**REGULAR MEETING OF THE PLANNING BOARD
WEDNESDAY, JULY 26, 2017
7:30 PM
CITY COMMISSION ROOM
151 MARTIN STREET, BIRMINGHAM**

**CITY OF BIRMINGHAM
PLANNING BOARD ACTION ITEMS
OF WEDNESDAY, JULY 12, 2017**

SUBJECT: 375 S. Eton – The District Lofts
Final Site Plan & Special Land Use Permit Review – District Lofts Building B

Building Section

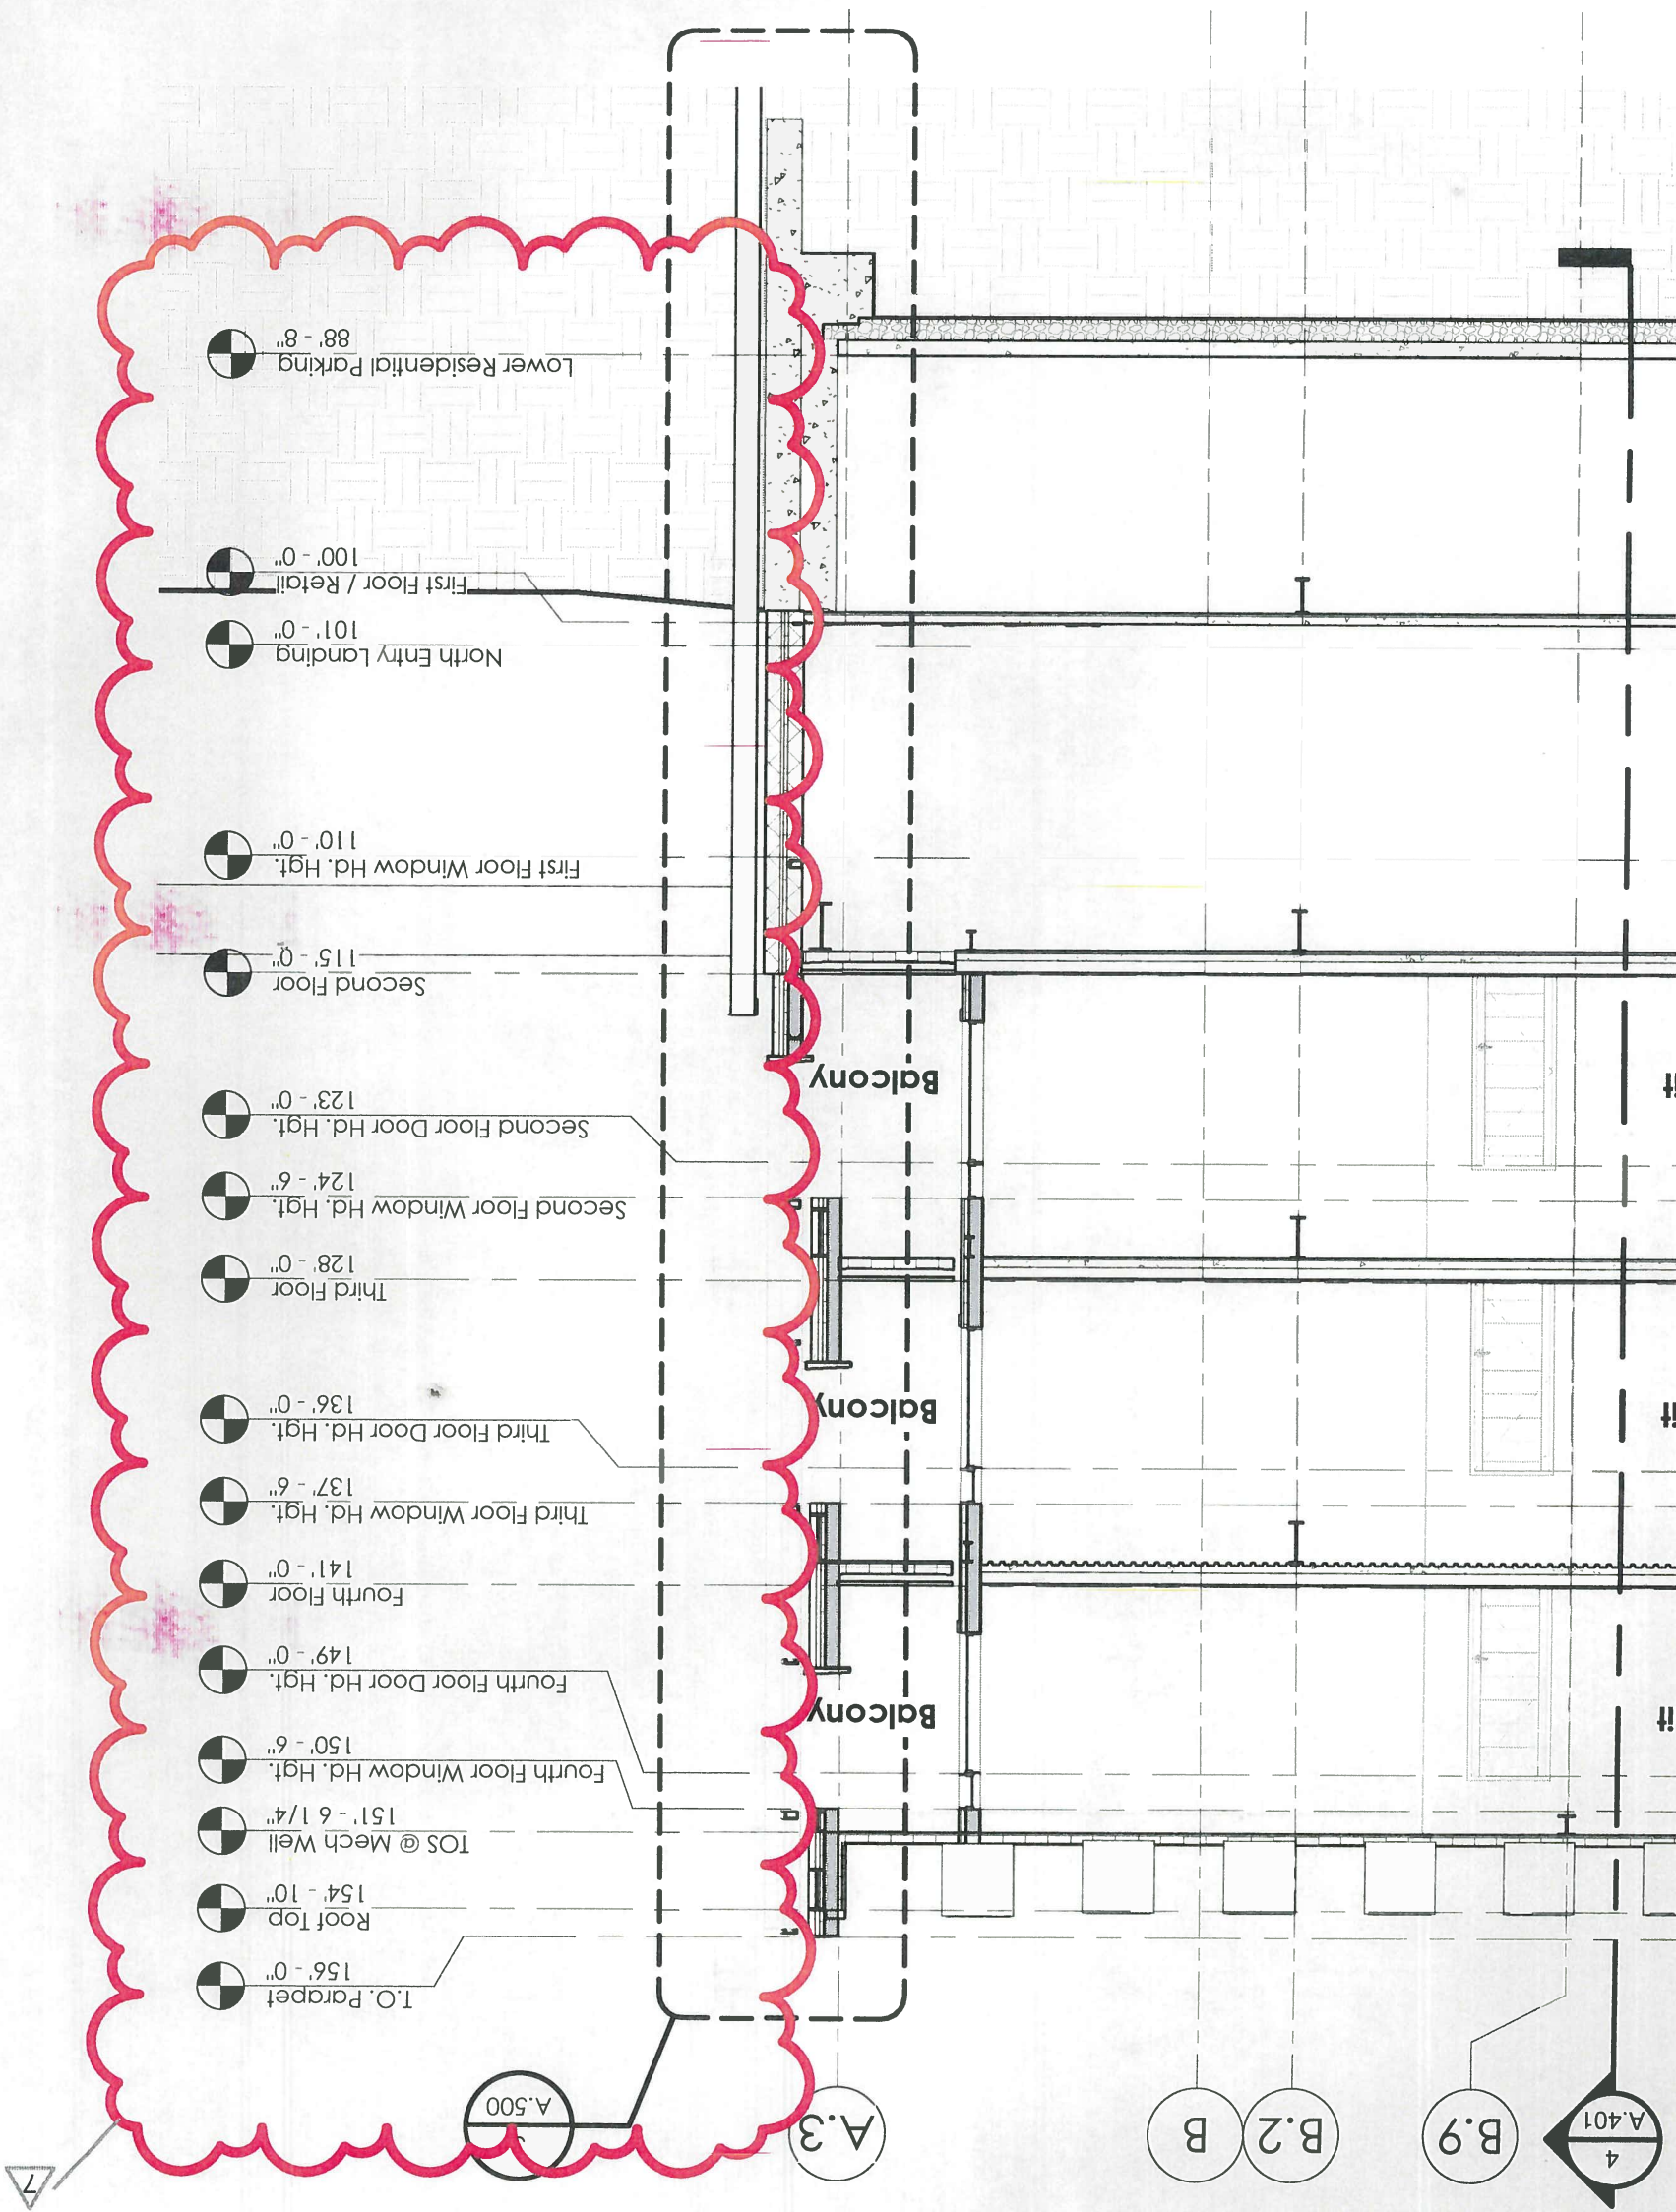
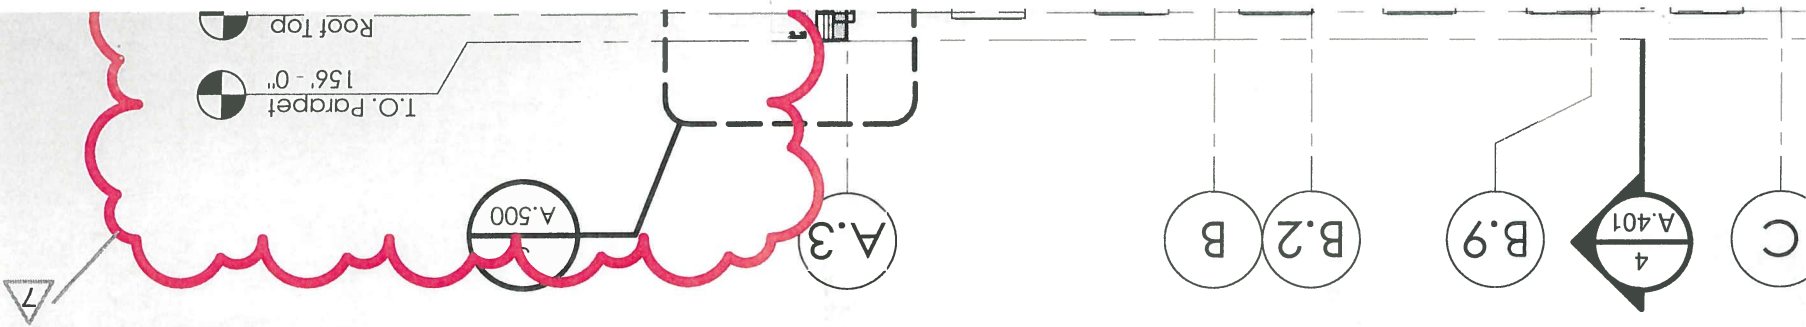
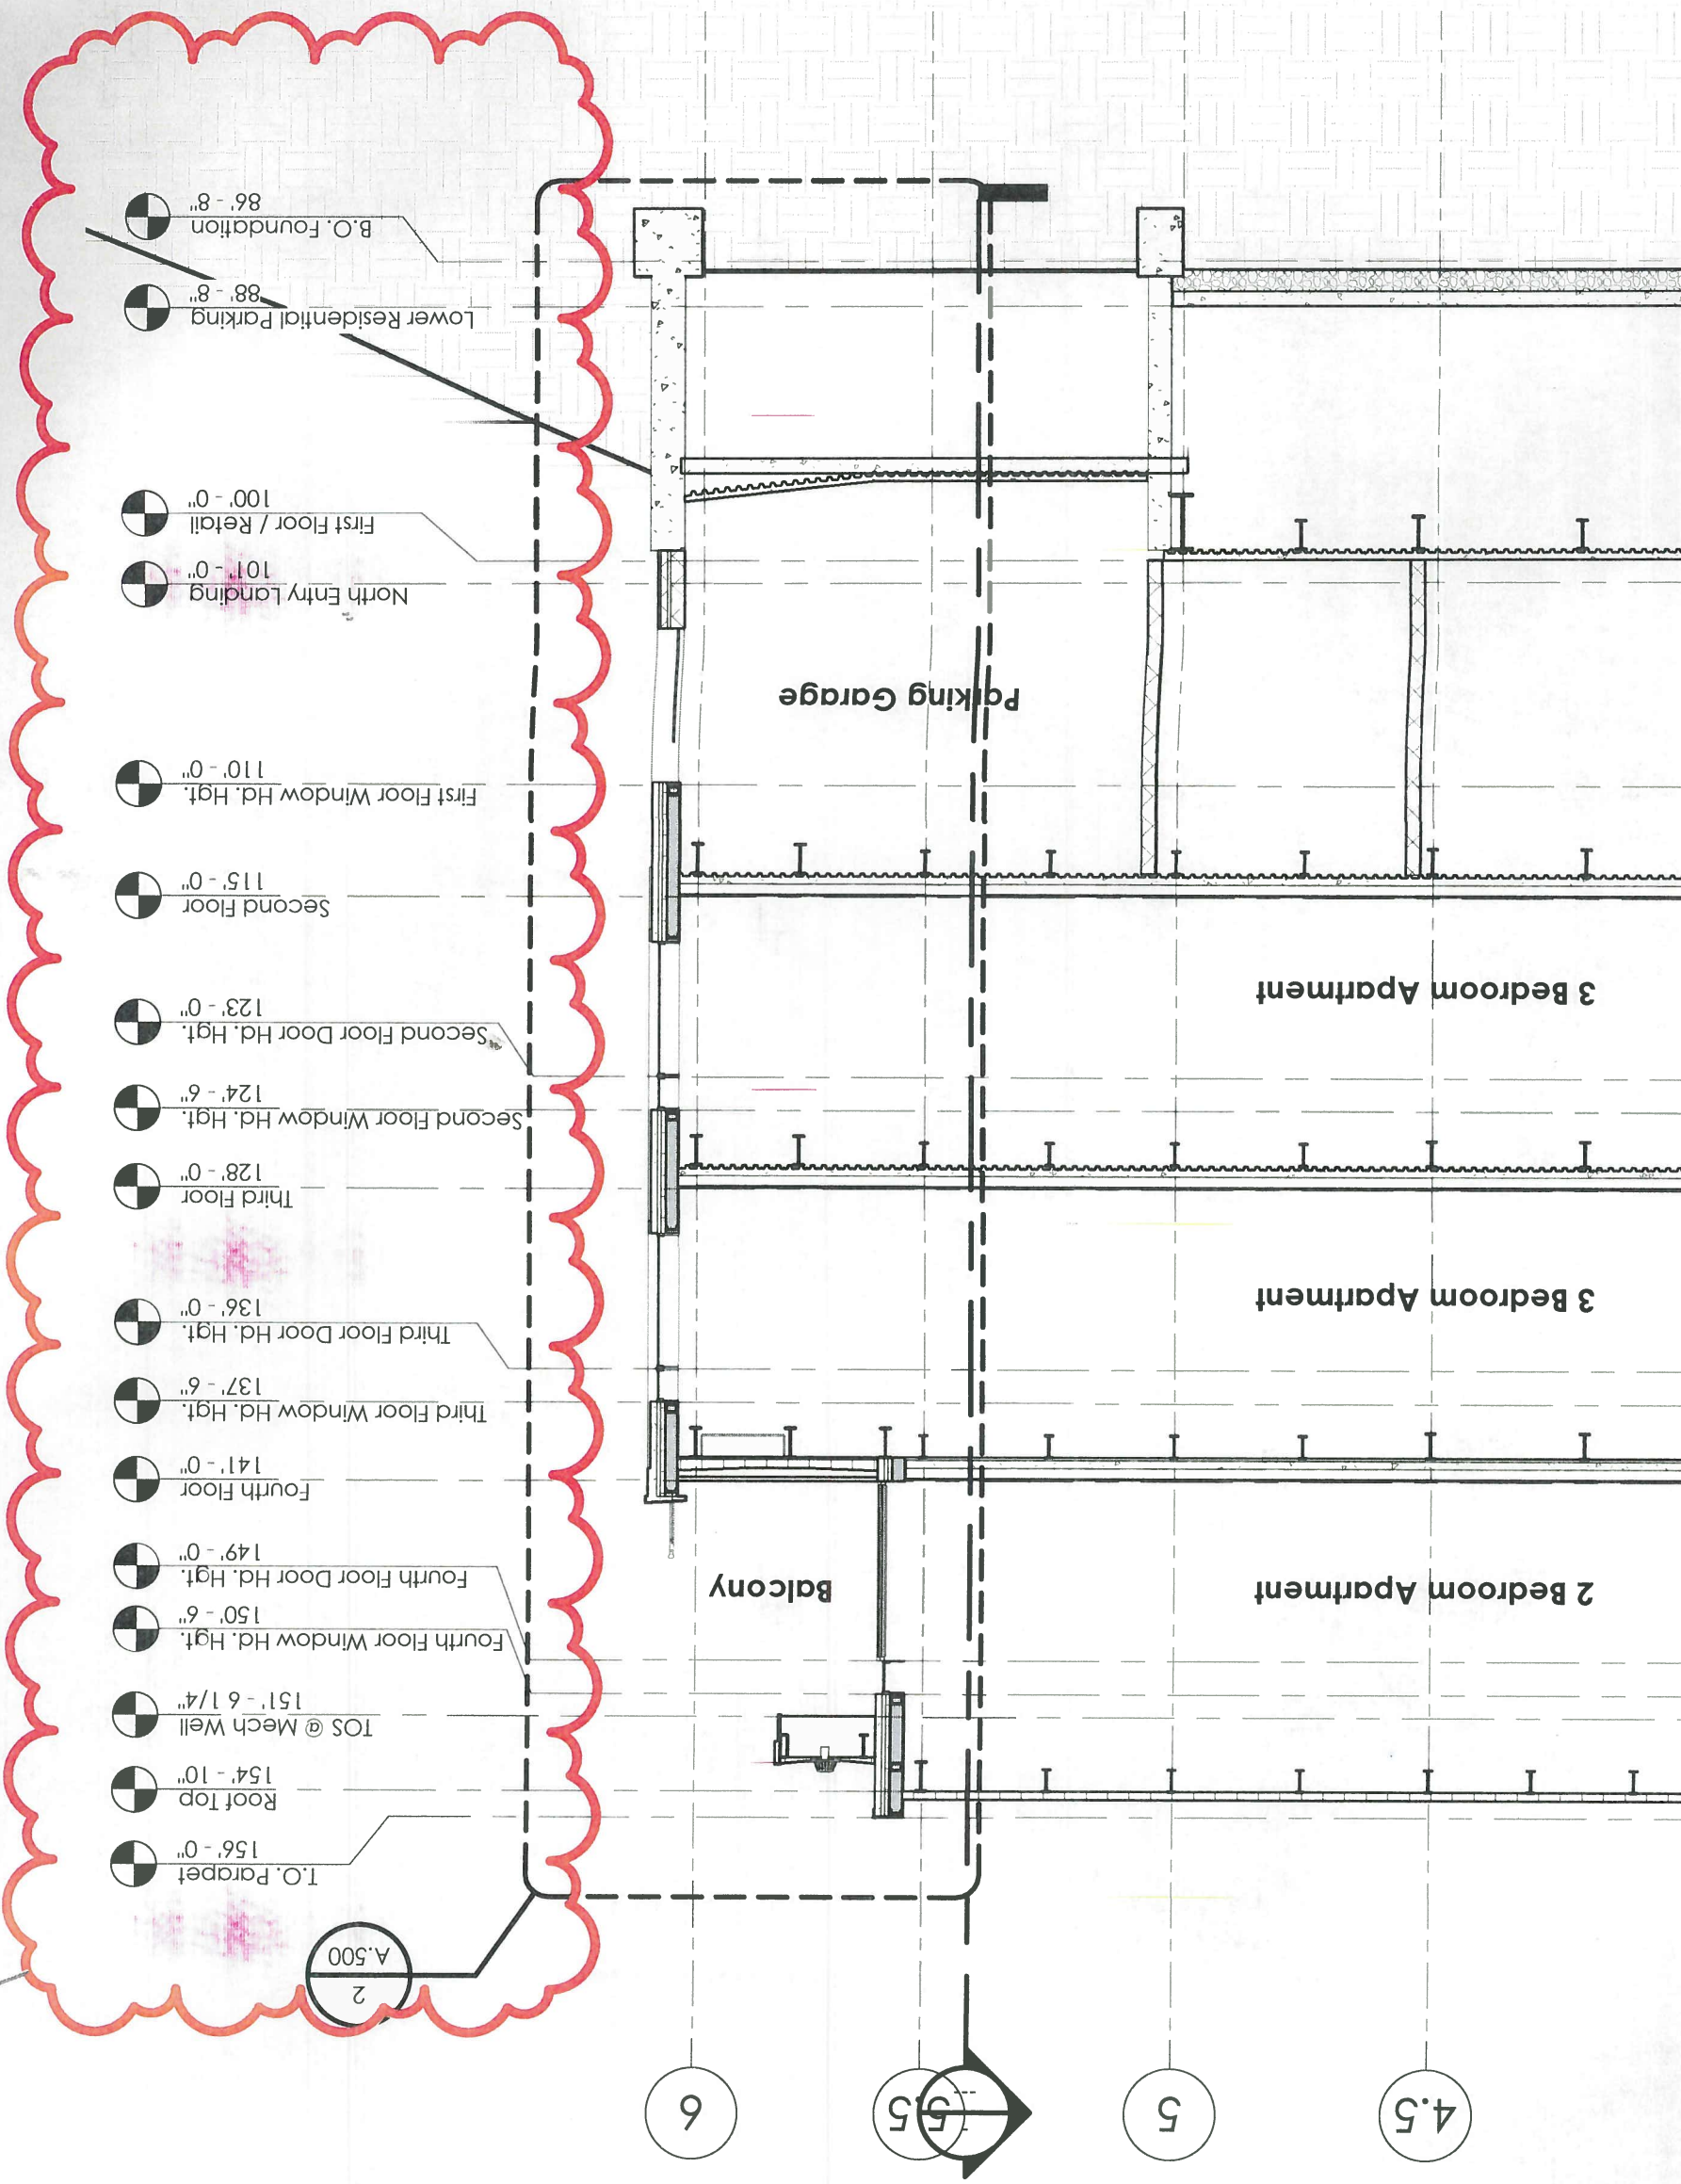
- The building plan shows a first floor height of 15', whereas the approved Final Site Plan shows 18'. **The applicant will be required to obtain Administrative Approval for this change.**
Request for administrative approval to change first floor height to 15'. Sheet A.400

- The building plan shows a second floor height of 13', whereas the approved Final Site Plan shows 12'. **The applicant will be required to obtain Administrative Approval for this change.**
Request for administrative approval to change second floor height to 13'. Sheet A.400

- The building plan shows a third floor height of 13', whereas the approved Final Site Plan shows 12'. **The applicant will be required to obtain Administrative Approval for this change.**
Request for administrative approval to change third floor height to 13'. Sheet A.400

- The building plan shows a fourth floor height of 15', whereas the approved Final Site Plan shows 14'. **The applicant will be required to obtain Administrative Approval for this change.**
Request for administrative approval to change fourth floor height to 15'. Sheet A.400
